UNITED STATES OF AMERICA  
 NUCLEAR REGULATORY COMMISSION

In the Matter of	)	
	)	
Dominion Virginia Power	)	Docket No. 52-017-COL
	)	
North Anna Power Station, Unit 3	)

**DOMINION VIRGINIA POWER'S  
 RESPONSES TO PRE-HEARING QUESTIONS**

Figure Q1-1 – Typical Subsurface Profile across Unit 3 Power Block Area  
(FSER Figure 2.5.4-1 Modified to Remove Vertical Exaggeration)

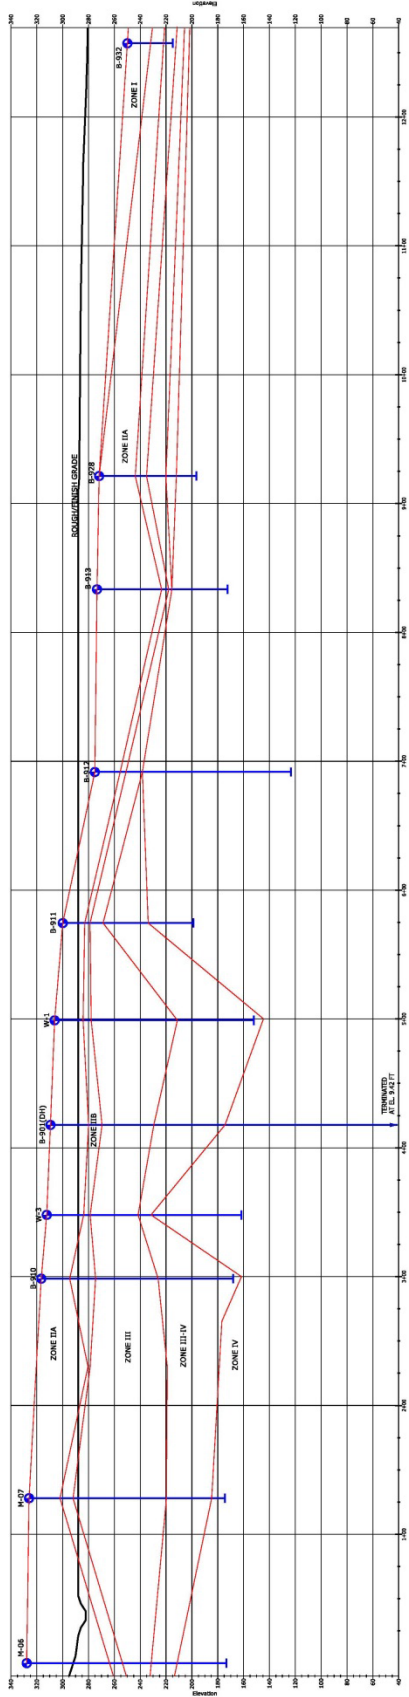
**Question 1:** In Request for Additional Information 5693, 2.5.2-3a, dated May 5, 2011 (ML11125A124), the Staff asked the Applicant to justify the one-dimensional (1D) site response analysis using only vertically propagating shear waves, given the complex topography of the subsurface layers. On August 25, 2011 (ML11241A058), the Applicant responded that the soil and rocks at the site are all derived from the same parent rock. The Applicant attributed the subsurface variability to the localized effects of weathering on minerals comprising the parent rock rather than to deposition of soil as distinct layers. For lateral variability, the Applicant states that the boundaries between rock types are gradational and so do not represent lateral impedance boundaries that may result in refraction, reflection, or trapping of the shear waves traveling in horizontal directions. Therefore, the site can be characterized as undulating, but not *dipping*, thus justifying the 1D analysis. The Applicant uses the same weathering process to explain the existence of vertical variation, but with distinct boundary impedances at different depths as shown in Final Safety Evaluation Report (FSER) Figure 2.5.2-5. Please discuss why the same weathering mechanism generates sharp boundaries vertically, but not laterally.

The end product of rock weathering depends on the composition of the rock and the weathering processes. The various stages of the weathering in place of the North Anna bedrock can be seen in Figure Q1-1 (FSER Figure 2.5.4-1 modified to remove the vertical scale exaggeration). The sound bedrock (Zone IV) degrades to slightly-to-moderately weathered rock (Zone III-IV), then weathered rock (Zone III), then saprolite (Zones IIA and IIB) which is mainly granular soil that still exhibits the structure of the bedrock, and finally clay soil (Zone I) which contains no relict bedrock structure and is now mostly absent from the site. Because of the vertical progression of the weathering process, these zones are nominally horizontal. Some random lateral variation (as seen in Figure Q1-1) occurs because the weathering processes are not always uniform, and the rock is not entirely homogeneous. It should be noted that the zone separations depicted on the figure are made by joining the zone boundaries in the borings by straight lines for simplification

– in reality these changes will be a gradual transition (similar to the ground surface) and thus the description of “undulating.”

The question references FSER Figure 2.5.2-5 (shear wave velocity ( $V_s$ ) profiles for the Reactor Building/Fuel Building (RB/FB) and Control Building (CB) used in site response analysis) as depicting the distinct boundary impedances at different depths. As described above, these are boundaries of variation of impedance in the vertical direction (termed “vertical impedance boundaries” here) defined by the approximately horizontal zone boundaries caused by weathering. Because the weathering impact on the rock is severe, the vertical impedance boundaries are significant, as illustrated in FSER Figure 2.5.2-5. The random and relatively small lateral variations as shown on the figure do not produce equivalent lateral impedance boundaries. The vertical impedance boundaries of the  $V_s$  profiles in FSER Figure 2.5.2-5 are somewhat simplified for use as input to the site response analysis. The  $V_s$  values are averaged over 10 ft intervals, and thus the sharp impedance boundaries in FSER Figure 2.5.2-5 do not reflect the transitions between zones that inevitably occur in a weathering profile. These slight approximations are accounted for in the randomization of the  $V_s$  profile as part of the response analysis. Similarly, local variations in the  $V_s$  profile due to variations in the weathering patterns are taken into account in the randomization process.

The question notes the reference to the site being characterized as undulating rather than dipping to justify the 1D analysis. In a dipping rock site, layers that are present on one end of the site may be absent on the other end, and vice versa. If these layers have distinctly different dynamic properties ( $V_s$ , damping, etc.), then the site response can be quite different at either end of the site – and additional analytical efforts would be needed to reconcile this situation. As described above, this is not the case with the undulations at the North Anna site.
